REMARKS

USSN 09/772,325 Page 20

FIG.1

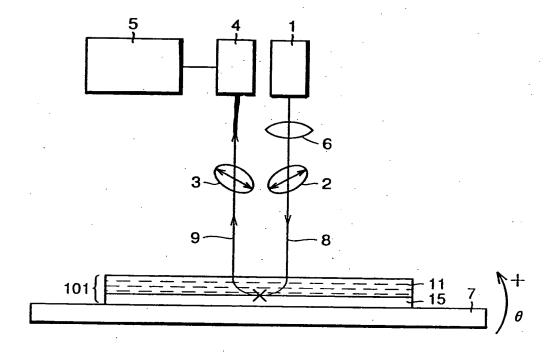
As to the §112 rejections and objections, applicant has amended Fig. 1 of the drawing to show the reflected light beam 9 as reaching the light receiving means 4, and has amended claims 1, 4, 9, 10, 12, 13, 17, 19, 20, 25, 27-29 and 33 to delete clear errors, include express definitions of symbols, and provide clear antecedent bases.

The specification at pages 32-33 describing the use of monochromatic light and not using a spectroscope relates to the light-receiving component 4, not a rotation of the polarizers or the stage 7. Further, this light-receiving component is shown in Fig. 1 as a functional box. In the embodiments using white light, a spectroscope is used in the light receiver 4, as described. When monochromatic light is used, a spectroscope per se is superfluous, and, as stated on pages 32-33, not used.

In view of the foregoing amendments and remarks, and in view of the accompanying corrected Fig. 1, applicant urges that the application is in conditions for allowance.
